ELECTRICAL POWER - ENHANCED CLEARANCE FOR PEDESTAL WIRE HARNESSSES

MTB-24-01  
Page 1 of 8

New anchors in the pedestal provide enhanced clearance for wire harnesses.

This service document provides parts and instructions to enhance clearance for wire harnesses in the pedestal.

Figure 1. Pedestal Wiring Inspection / Modification (Sheet 1)

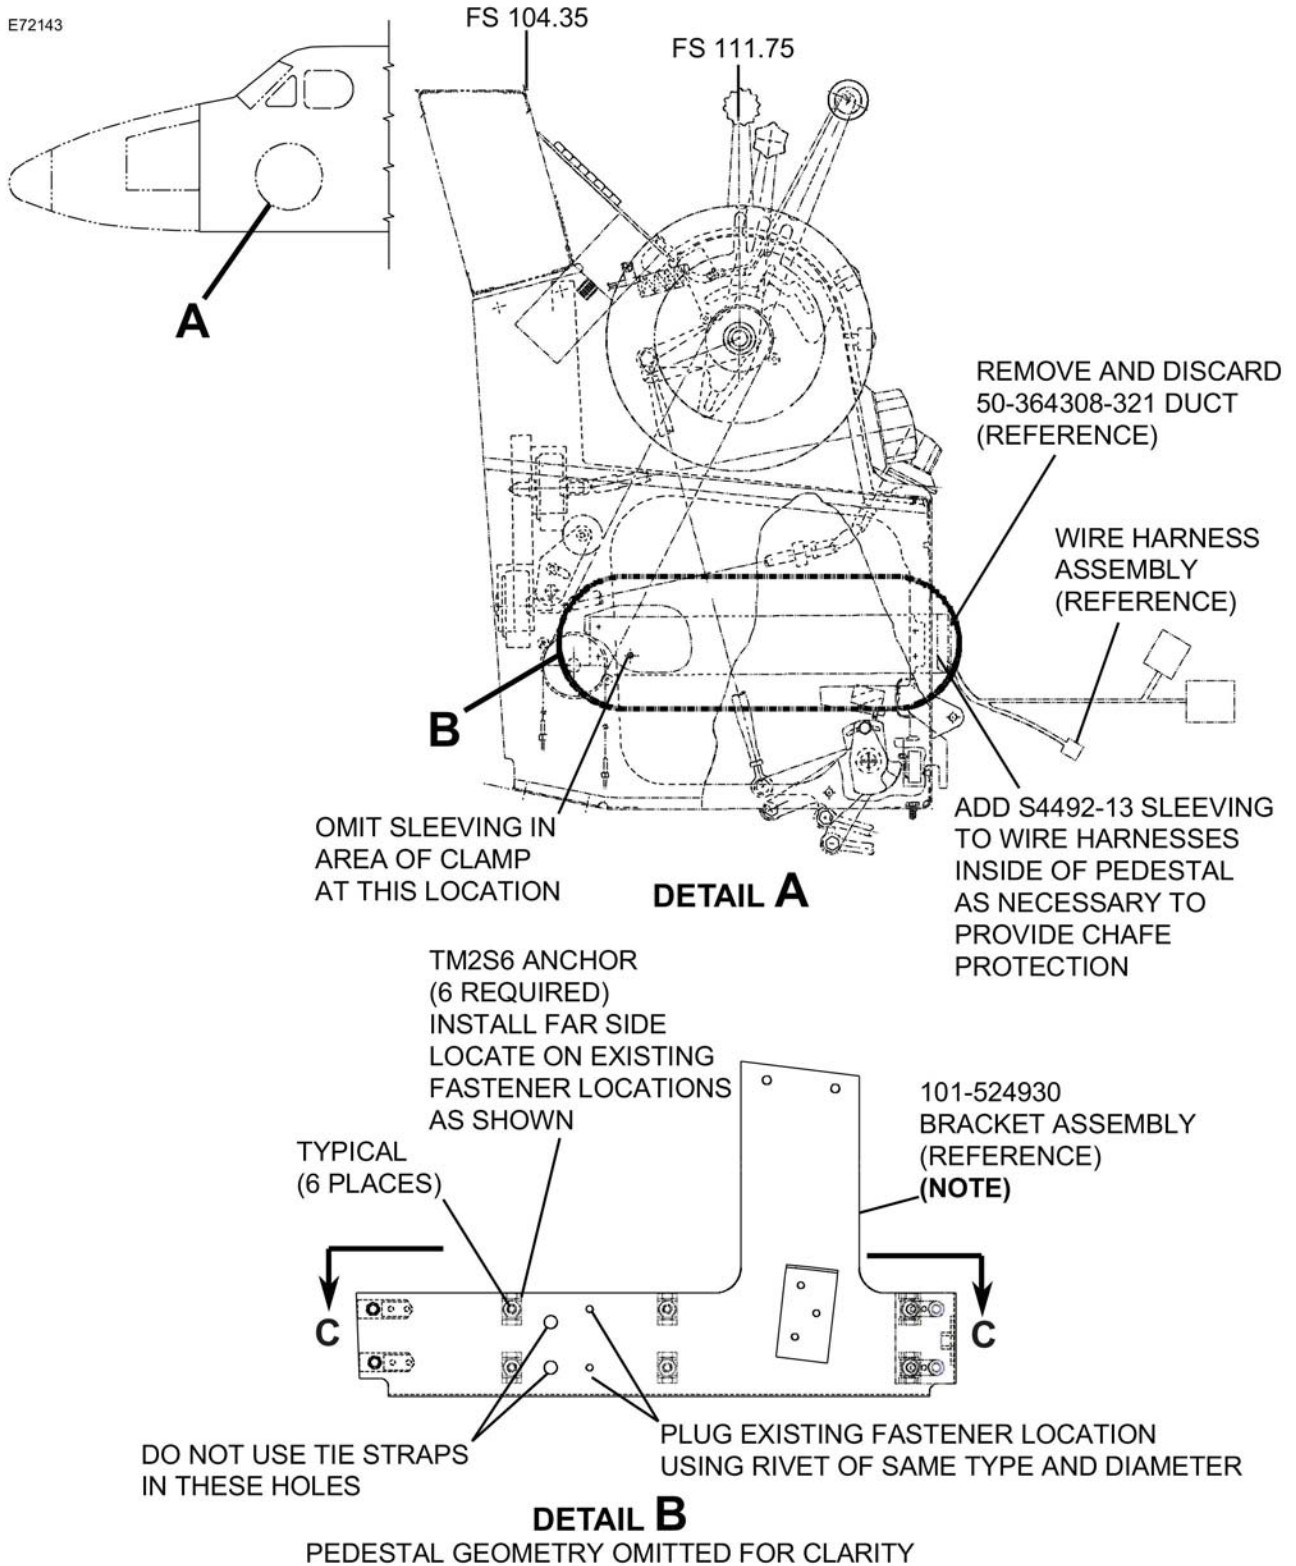
8. Remove and discard 50-364308-321 Fiberglass Duct. Do not remove existing bracket assembly.
9. (Refer to Figure 1, Sheets 1 thru 3.) Accomplish the following:

- A. Use MS35206-226 Screws and MS21042L06 Nuts to install four TM2S6 Anchors at open rivet locations at side of pedestal.
  - B. Use MS35206-226 Screws and MS21042L06 Nuts to install two TM2S6 Anchors at open rivet locations along long aft flange.

- C. Plug open rivet locations.
  - D. Separate wire harness assemblies along both rows of anchors.
  - E. Wrap S4492-13 Sleeve around rerouted wiring along length as shown. Sleeve should be omitted in area of the clamp at forward end of the pedestal.

- F. Tie strap sleeved harness and attach to new anchors using S2209-5 Wire Ties.
  - G. Orient tie straps to maximize clearance with surrounding structure.

- H. Make sure a minimum 0.25-inch clearance exists between harnesses and control rod.
  - I. Move pilot controls to verify that no contact exists between harnesses and control rod.
